Amendment GC81

Fishermans Bend- Lorimer

Expert Urban Design Evidence

March 2018

Draft Framework, Figure 20

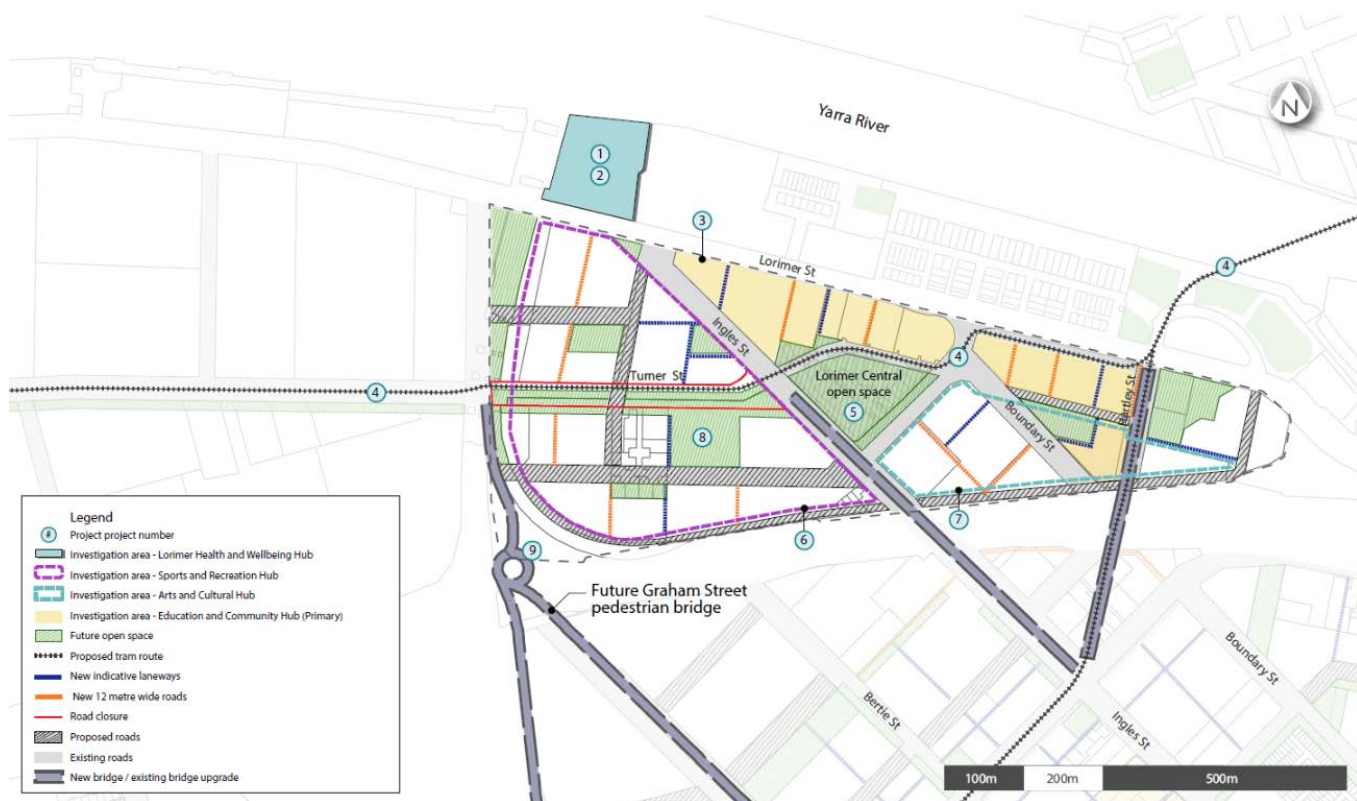
- [25] The Infrastructure delivery diagram for Lorimer in the Draft Framework (Figure 20) indicates a series of north-south streets and laneways.

However, these are not shown in Map 2 in the proposed CCZ schedule. Instead, the proposed local policy seeks the provision of laneways no more than 50m apart in core areas such as this.

- [26] As noted in my overarching evidence, I support the flexibility for the alignment of laneways to be determined as part of the design of the relevant properties' development. However, I consider that the planning framework should go further in Lorimer and encourage the laneways to be oriented north-south, to realise the strategy in the MSS. This could form an additional dot point in the local policy under **New streets, laneways and pedestrian connections**.

- [27] In the short term, a 'pop up' community hub and a health and wellbeing hub are proposed on the north side of Lorimer Street, overlooking the river (items 1 and 2 on Figure 20 of the draft Framework), with an education and community hub somewhere along Lorimer Street (item 3). In the long term, a sport and recreational hub is proposed somewhere in the western half of the precinct, and an art and cultural hub is proposed in the southeastern part of the precinct.

Maps from the proposed CCZ and DDO

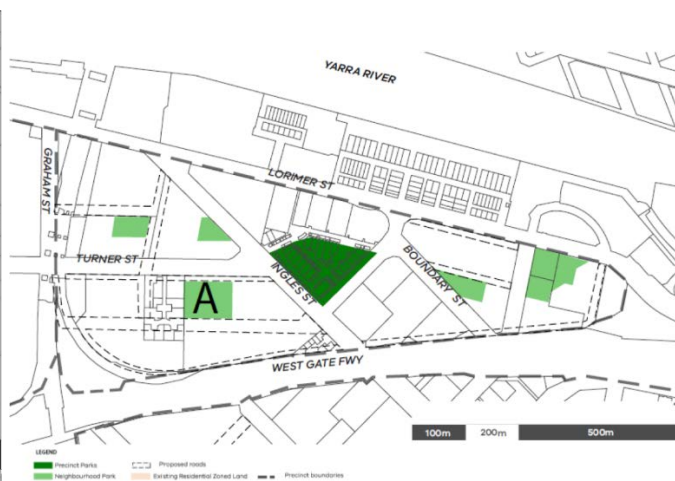
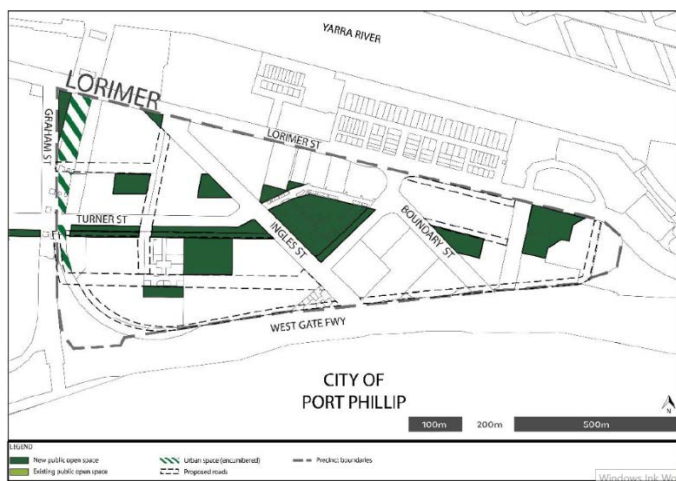
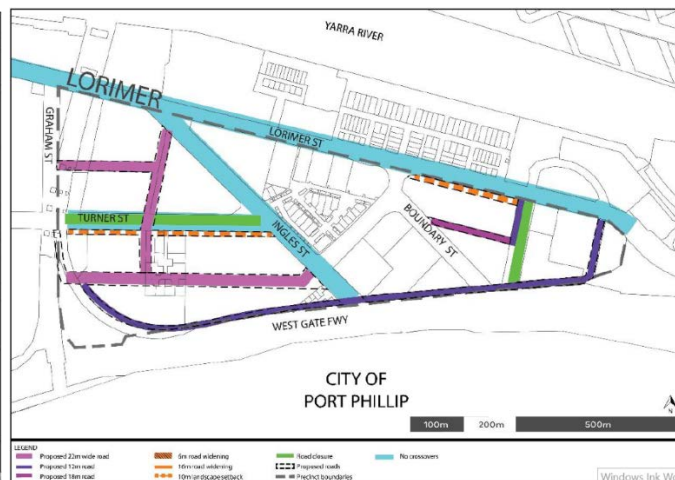
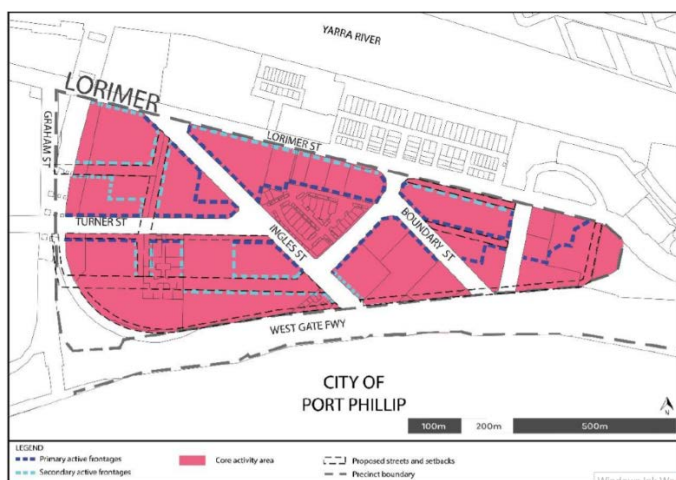
[39] It is unclear why the northwest corner (between Lorimer, Ingles and Turner Streets and Citylink) needs to be limited to 24 storeys in height. This will not prevent the 'parkway' from being overshadowed (nor do I think that it warrants sunlight protection). I consider that the degree to which it feels overwhelmed by development will be governed by the scale of the street wall, and tower separation, rather than the height of the buildings.

^[41] I presume that the reason the land on the corner of Turner and Ingles Streets is proposed to be limited to 12 storeys is to avoid overshadowing the proposed open space to its south. And I assume the same reasoning has led to the preferred maximum heights north of the Lorimer Central open space. However, sunlight to these spaces is already protected by the overshadowing provisions within the proposed DDO.

[43] It is unclear why development fronting Lorimer Street between Boundary Road and Hartley Street (Subaru) is limited to 18 storeys. It does not appear that this would be sufficiently low to ensure solar access to the proposed open space to its south. In any event, I note that Ms Thompson proposes to reconfigure this park so that it has a northerly aspect.

[45] Therefore, I recommend that the proposed preferred maximum heights in Lorimer be removed. This is not to say that there should be no limit on development scale. However, because there are no specific reasons to constrain height in this precinct (other than solar access to open space, which is dealt with by the overshadowing control), I consider that a density control provides a more appropriate measure to control the scale of development (in conjunction with general policy, such as that found at clause 15, requiring development to respond to its context). This is because it allows the flexibility for lower, broader buildings (which may suit office uses), or taller, slender forms (which may suit residential uses). The visual impact of tall buildings will be offset by the greater separation that would be necessitated by a density limit.

Recommended changes to open space in Ms Thompson's evidence, Figure (ix)

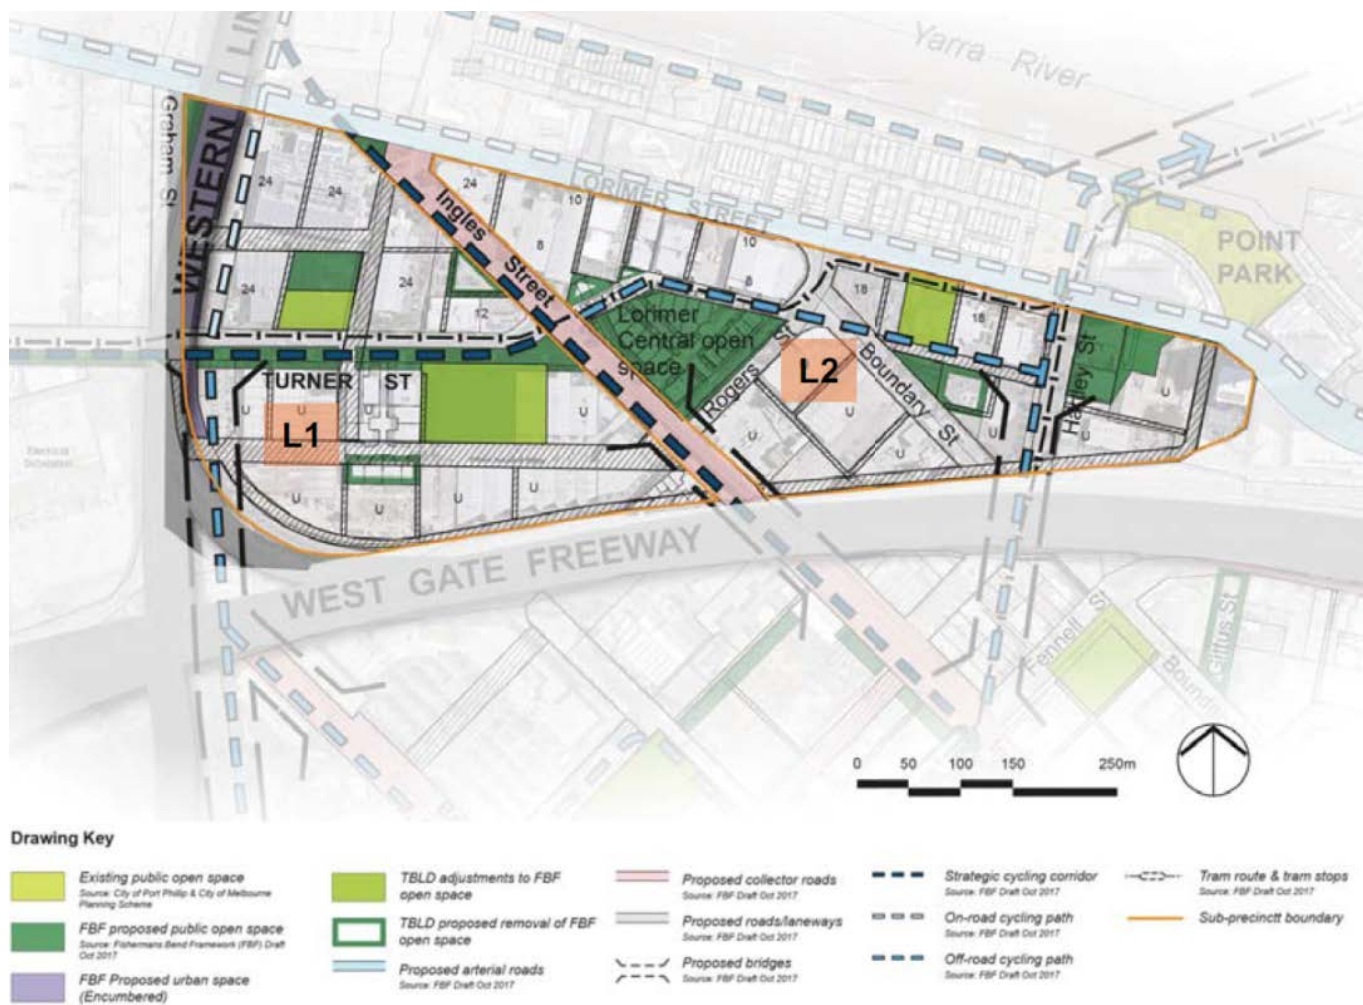
- [32] Ms Thompson proposes amendments that would increase the open space area to 4.1ha, which represents 14% of the precinct area and 3.4m² per resident. These include:

- Deleting the remnant triangular open spaces alongside the northern edge of the proposed northern tram line at 350 Ingles Street and the back of 876 Lorimer Street
- Deleting the proposed park at 351 Ingles Street (Melbourne City Jaguar/ Volvo)
- Deleting the proposed park at the southern edge of 200 Turner Street
- Deleting the eastern end of the proposed park at 99-111 Lorimer Street (Subaru), and extending the remaining park north to Lorimer Street
- Extending the proposed park at 161 Turner Street south to Turner Street
- Enlarging the proposed park in the northwest corner of 220 Turner Street

[33] In essence, Ms Thompson's proposition is to consolidate the open space into a smaller number of larger neighbourhood parks, to enable them to incorporate a wider variety of facilities, improve their solar access and improve the connection to the river. She notes that the resulting parks will still meet the 200m easy walking catchment requirement.

[34] I agree that the proposed open space pattern is somewhat fragmented, and support Ms Thompson's recommendations. However, I note that placing larger open spaces on fewer properties may affect the equity of the land acquisition mechanism and the ability of these properties to realise their notional maximum floor area within the proposed building envelope controls.

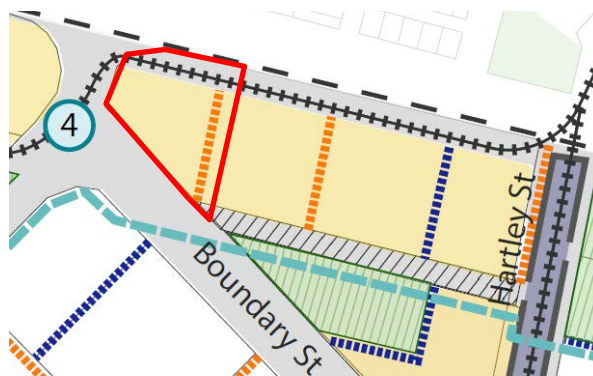
The site can accommodate the maximum dwelling FAR and minimum non-dwelling FAR within the proposed built form controls by adopting a podium and tower form to a total height of 17 storeys within the developable site area. However, if the proposed 12m wide road is located within the site then the site will not be able to accommodate the maximum FAR.

At this height there are no winter overshadowing issues to the Lorimer Central Park. The southern edge of the tower requires additional setbacks at the upper levels to prevent overshadowing of the southern neighbourhood park.

There is capacity for a tower to be taller than the preferred maximum height while still avoiding shadowing of the park to the south during the September equinox, if carefully sited. Even at 40+ storeys, a tower would not cause overshadowing of the Lorimer Central Park during the winter solstice at 11am-2pm.

I note that Ms Thompson's evidence recommends that part of the southern open space be relocated to sit alongside the eastern boundary of this site. This would have significant consequences for the development of the site and may mean that the maximum FAR cannot be achieved.

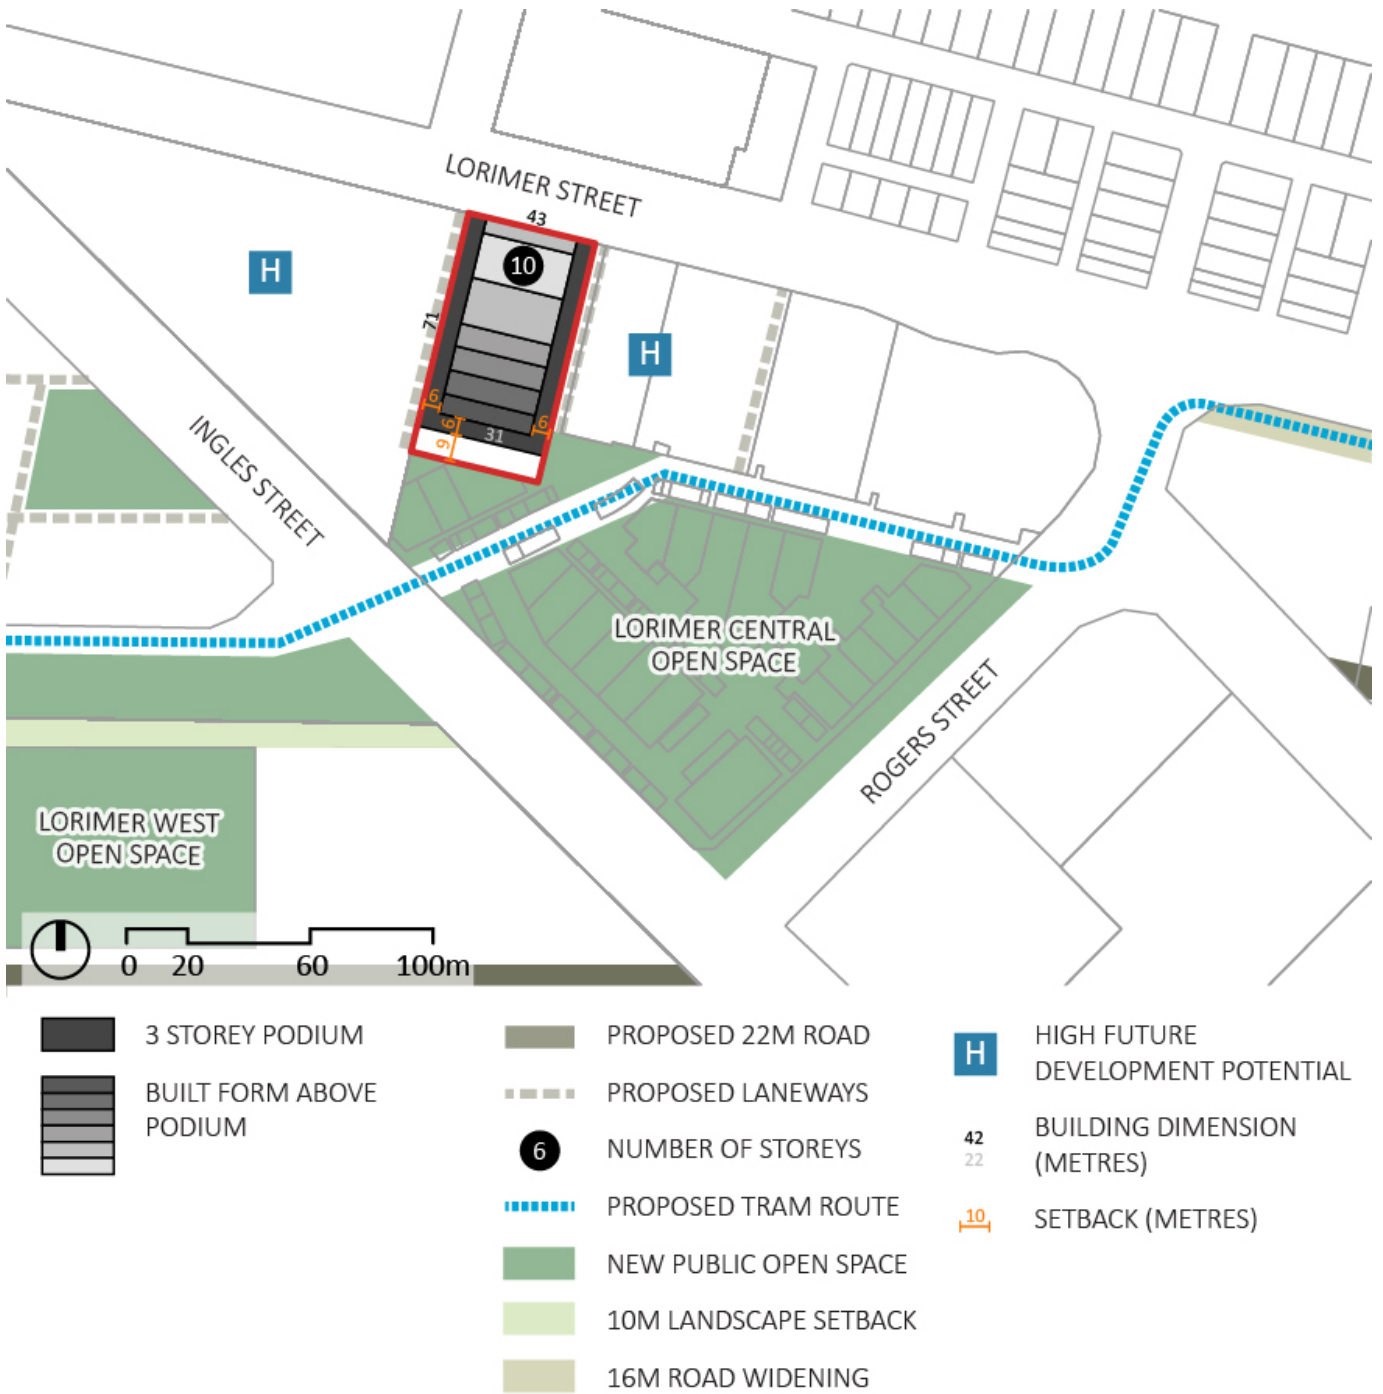
The site cannot accommodate the maximum dwelling FAR and minimum non-dwelling FAR within the proposed height, setback and overshadowing controls.

The non-dwelling GFA and dwelling car park GFA can be accommodated in a 3-storey podium. The dwelling GFA (minus car parking) can be principally located in the storeys above. An 8-storey street wall can be provided on Lorimer Street. However, the upper form would need to step down to the rear in order to avoid overshadowing the park to the south.

The 8–10 storey height limits are unnecessary in this location because the shadow requirements will limit building height.

The street wall height and setback requirements also limit the design response for the site, which prevents it from being able to reach the maximum FAR.

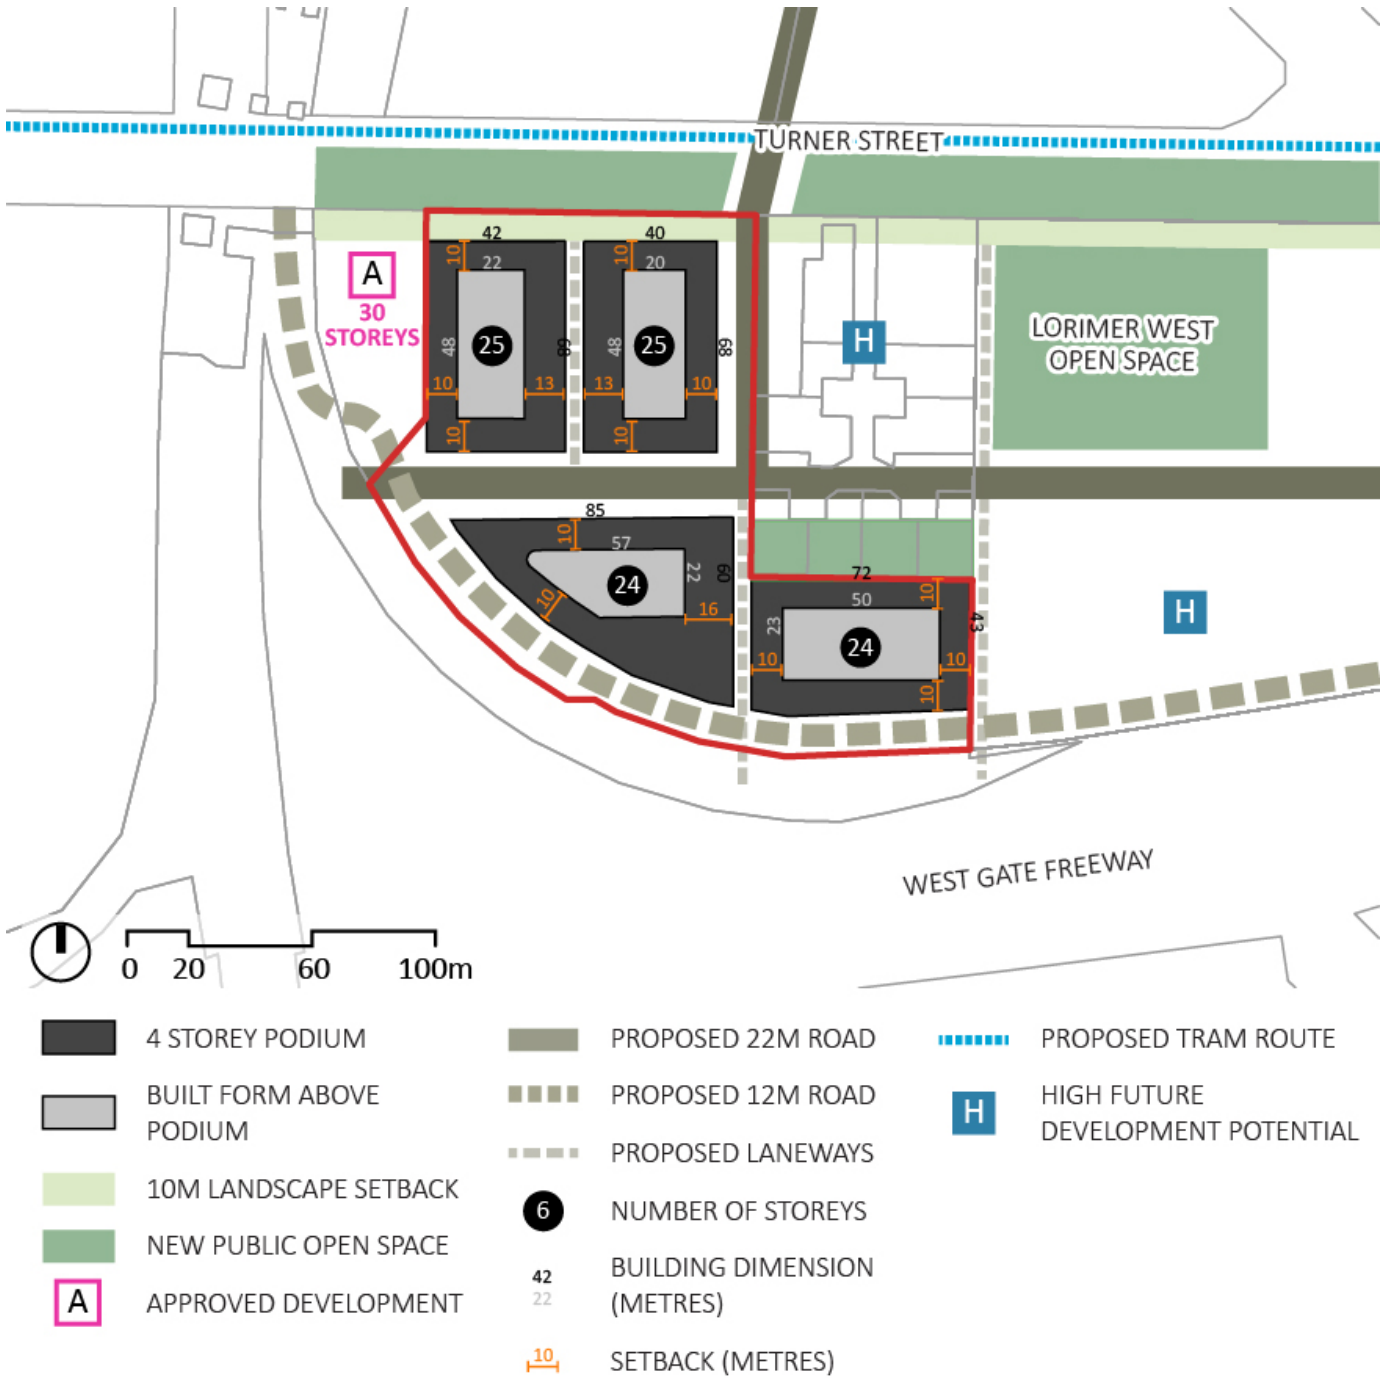
The site can accommodate the maximum dwelling FAR and minimum non-dwelling FAR within the height and setback controls by adopting podium-tower forms.

The non-dwelling GFA and dwelling car park GFA can be accommodated in 4 storey podiums. The dwelling (minus car parking) GFA can be principally located in 20-21 storey towers above the podium, resulting in total heights of 24-25 storeys.

The maximum GFA limits the towers to 25 storeys (although additional height could be developed for non-dwelling use). However, in this context there would be no detrimental amenity impact from taller towers. The development could then accommodate additional dwelling or non-dwelling GFA.

The proposed unlimited height in this location, and the capacity to accommodate additional GFA within the built form controls, suggests that the proposed density limit unnecessarily limits the capacity of this site.
